TECH BULLETIN

076
1/96

SUBJECT: Valve Seat Change 2530 and 2537 Pumps

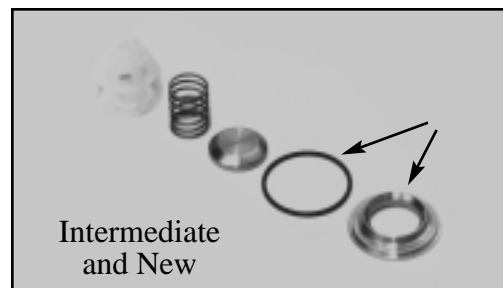
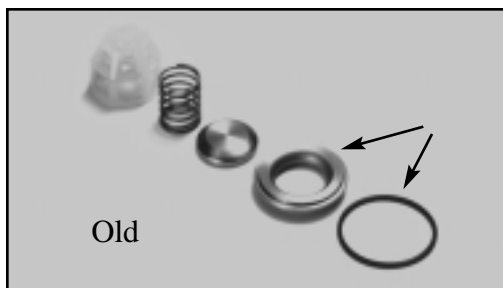
Recently the valve seat and o-ring design was changed to enhance performance life of this pump, particularly in harsh conditions.

The original design called for the o-ring to be installed onto the lip of the seat, after the valve seat was installed. This position periodically allowed the o-ring to extrude and contribute to possible erosion in the manifold chamber.

Effective with 695 mfg date, the o-ring was moved to the back side of the valve seat with the o-ring installed first, onto the lip in the manifold chamber, then the valve seat with the **machined o-ring groove down**.

Effective with 1195 mfg date, the valve seat was modified to a new thicker style, still with the o-ring installed first, onto the lip in the manifold chamber, then the valve seat with the **machined o-ring groove down**.

Kit 33951 will service all pumps prior to 1195 mfg date, while kit 33952 will service all pumps after 1195 mfg date. If the 33952 is used to service an old style pump, all 6 valve seats must be upgraded to the new 46857.

★ Both old and intermediate parts are no longer available. Upgrade to new thicker valve seat requires all six valve seats or two kits.
